SUBJECT: ISSUANCE OF AMENDMENTS (TAC NOS. M96898, M96899, M96900 AND M96901)

The amendments would update the pressure-temperature (P-T) curves contained in the Dresden and Quad Cities Technical Specifications to 22 Effective Full Power Years (EFPYs).

ATTACHMENT TO LICENSE AMENDMENT NOS. 153 AND 148

SAFETY EVALUATION BY THE OFFICE OF NUCLEAR REACTOR REGULATION  
RELATED TO AMENDMENT NO. 153 TO FACILITY OPERATING LICENSE NO. DPR-19,  
AMENDMENT NO. 148 TO FACILITY OPERATING LICENSE NO. DPR-25,  
AMENDMENT NO. 172 TO FACILITY OPERATING LICENSE NO. DPR-29  
AND AMENDMENT NO. 168 TO FACILITY OPERATING LICENSE NO. DPR-30  
COMMONWEALTH EDISON COMPANY AND  
MIDAMERICAN ENERGY COMPANY  
DRESDEN NUCLEAR POWER STATION, UNITS 2 AND 3, AND  
QUAD CITIES NUCLEAR POWER STATION, UNITS 1 AND 2  
DOCKET NOS. 50-237, 50-249, 50-254 AND 50-265

FIGURE 3.6.K-5

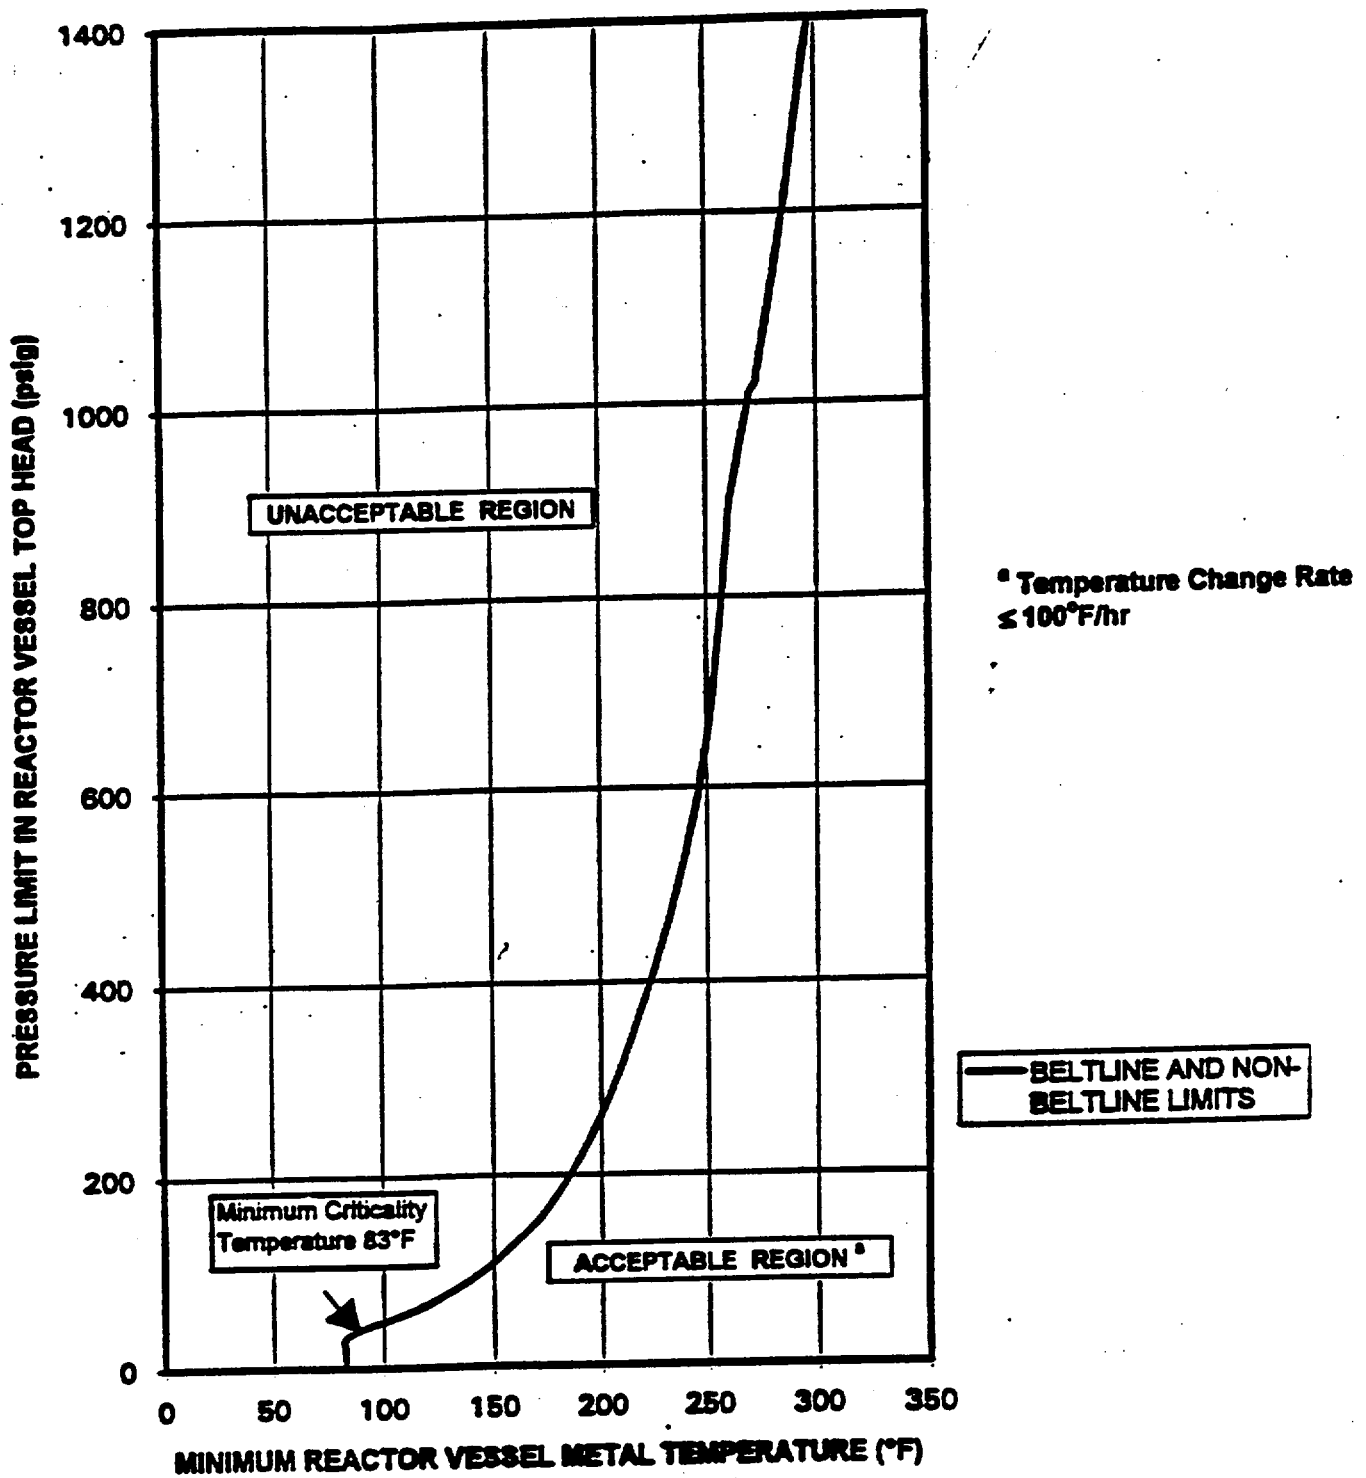
The core critical operation curve shown in Figure 3.6.K-5, is generated in accordance with 10CFR Part 50 Appendix G which requires core critical pressure-temperature limits to be 40°F above any Pressure testing or non-nuclear heatup/cooldown limits. Since Figure 3.6.K-4 is more limiting, Figure 3.6.K-5 is Figure 3.6.K-4 plus 40°F. The maximum heatup/cooldown rate of 100°F/hour is applicable.
